SECTION 73 OF THE TOWN AND COUNTRY PLANNING ACT 1990 (AS AMENDED)
 PERMISSION TO VARY PLANNING CONDITION 1 ASSOCIATED WITH PLANNING CONSENT 22/00208/FP
 MONKSWOOD RETAIL PARK, ELDER WAY, STEVENAGE, SG1 1TL

On behalf of the applicant (GRIDSERVE Sustainable Energy Ltd), I hereby enclose various accompanying details in regard to the variation of condition relating to the electric vehicle charging hub and associated works at the Monkswood Retail Park, Elder Way, Stevenage, SG1 1TL

Proposed new layout

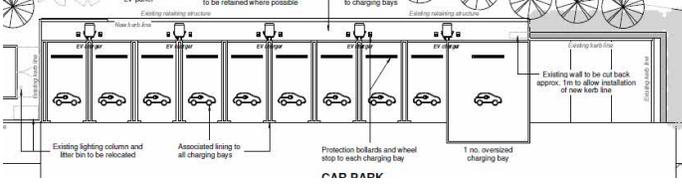
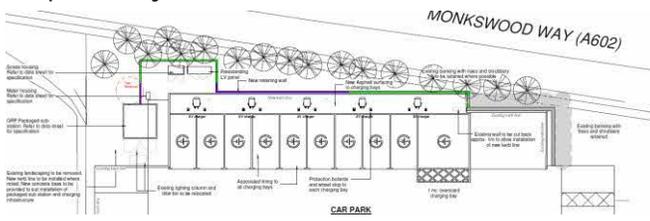
Planning Condition to vary (summary from Decision Notice)	Supporting Text and other Documentation
<p>1 - Approved plans; updated to reflect the revisions to the EV Hub layout</p> <p>A. Previous Approved drawing approved as part of the NMA.</p> 	<p>Following a technical review of the proposals the scheme has been amended. The following design amendments have been incorporated.</p> <p>A. The minor re-siting of the ancillary kit. Further investigation post consent has confirmed the presence of an easement for a gas main that was not previously identified on the initial utilities survey. The kit affected includes the substation, meter cabinet, feeder pillar and communications cabinet (SCADA). The re-siting has also necessitated the removal of the circulation areas between the bays and the regrading of the bank and the removal of some of the shrubbery and a tree. As such the revision to the layout will reduce the visual impact of the ancillary kit as the setting down</p>

of the kit through the regrading will mean that the kit's impact from the road will be significantly reduced. This regrading will also aid maintenance and remove a working at height safety issue that came to light post consent. The appearance of the kit will remain as previously consented. This will result in some minor loss of landscaping with the remainder being retained. The bay sizes will mirror standard car park bay sizes and will match the rest of the car park. It is not considered that the amendments will result in any significant impacts over and above those previously consented and they remain within the developable area for the site.
